Evaluation of proposed move for Water Right No 4148

Proposed: Move water right no. 4148 a distance of 419 ft to the southeast.

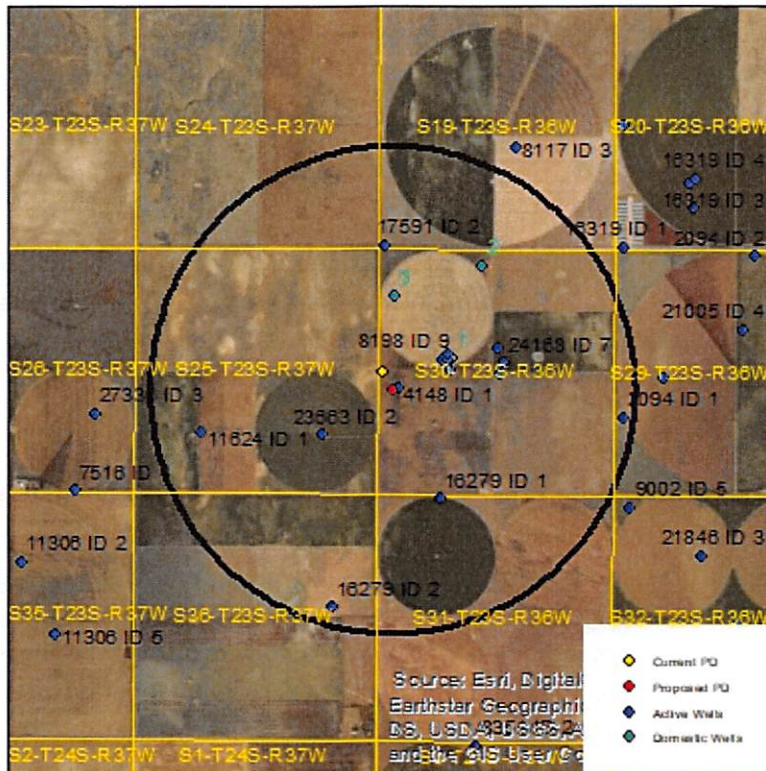
Wells within 1 mile: 8198 & 24168, 8198 ID 9, 24168 ID 7, 2094, 17591, 23663, 11624, 16279 ID 1, 16279 ID 2, and 3 domestic wells, numbered on the above map.

WELL TEST ANALYSIS

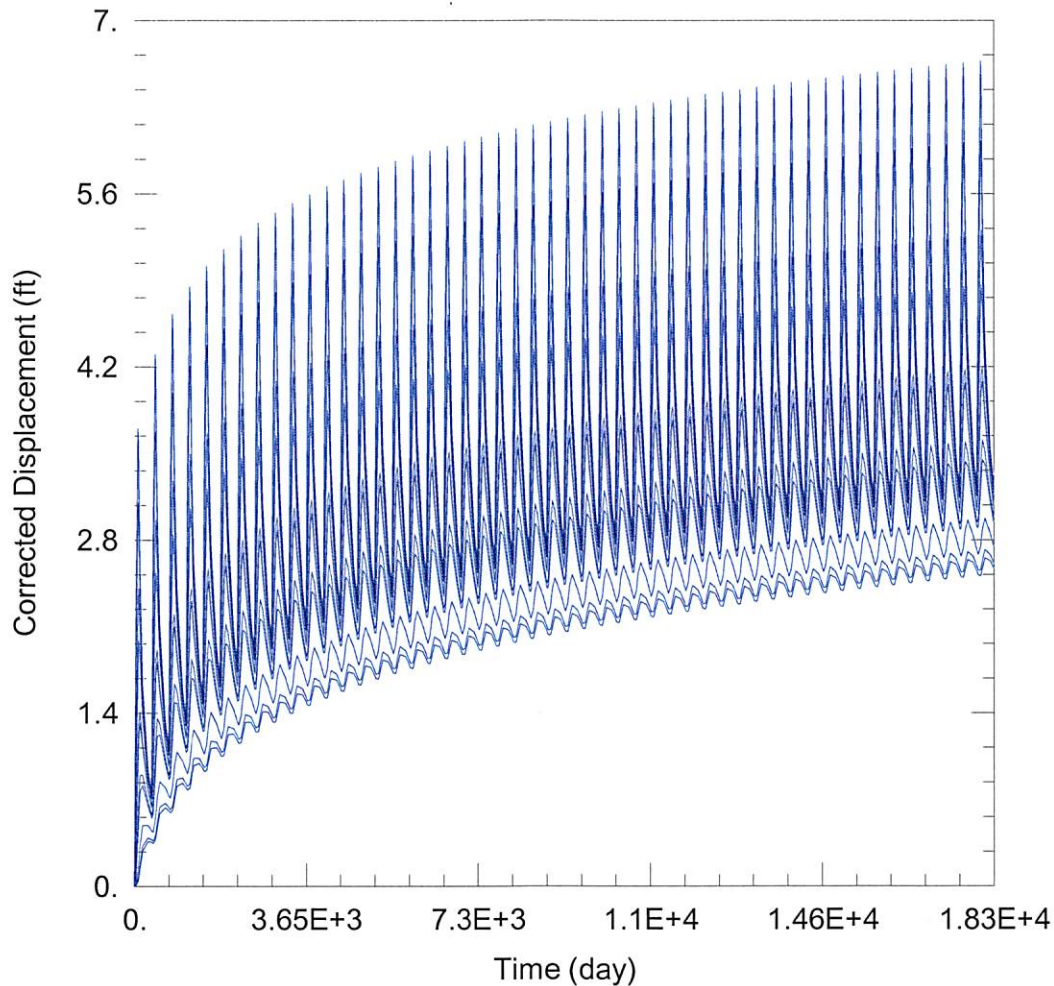
The proposed well location does not meet well spacing requirements under GMD3 rules. The proposed well location does increase spacing, which normally is an exception to spacing rules. However, that exception is based upon a presumption that increasing spacing will reduce well-to-well interaction effects. Since the well has not been operated at its current location for 35 years, the proposed well location is, for all intents and purposes, a new well with new effects on neighboring wells. GMD3 staff will review the application with the Board of Directors to seek recommendation after giving neighbors time to notify the GMD of any concerns they may have.
